TECHNICAL BULLETIN

[Issue No.] FA-A-0025

[Title] High-speed cyclic transmission (100Mbps) support of the MELSEC-Q series FL-net (OPCN-2) interface module

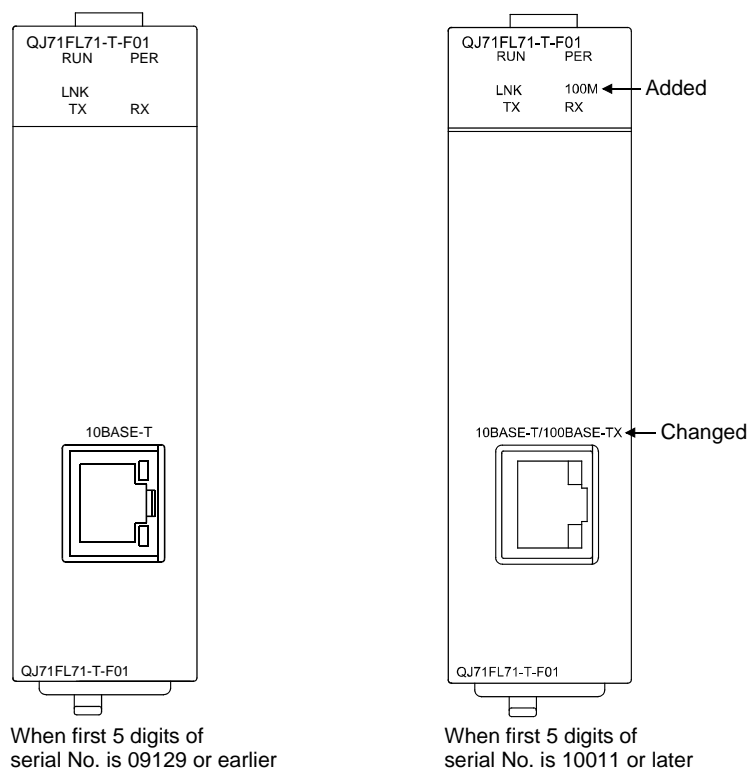
4. Changes in silkscreen print on the QJ71FL71-T-F01

With this functional addition, the silkscreen print will be changed for the product whose first five digits of serial No. is 10011 or later.
